## Labor Saver™: 2021-2006 Toyota and Lexus CUV Rear Stabilizer Bar Link

Brand	Supreme	Product	Stabilizer Bar Link	Date	March 2023
<b>Part Number(s)</b>	MS86854

**Figure 1.** Mevotech Supreme rear stabilizer bar link MS86854 with replacement hardware and bushings, larger diameter connecting rod and greaseable self-lubricating sintered bearings (top) vs the OEM (bottom)

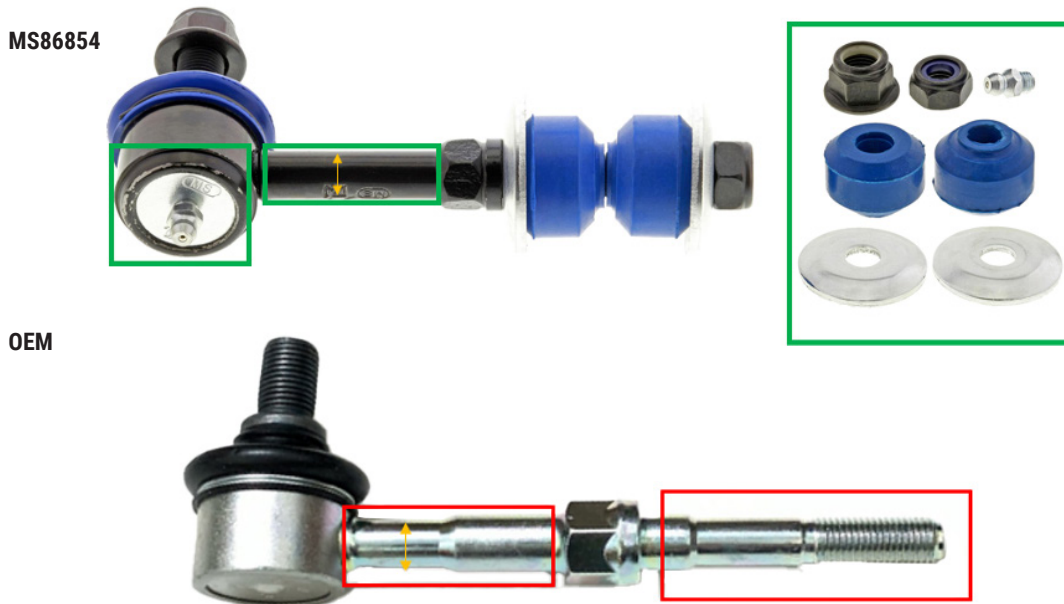
The OEM (PN: 48830-42020) rear stabilizer bar link for the application(s) listed below does not incorporate bushings or fastening hardware and utilizes a plastic bearing.

Mevotech Supreme replacement rear stabilizer bar link MS86854 incorporates new bushings and the entire assembly and fastening hardware is anti-corrosion coated, reducing installation time and providing more value in a repair option. Additionally, the stabilizer link is engineered with a thicker diameter connecting rod and greaseable self-lubricating sintered bearings for increased part strength and service life. **See Figure 1.**
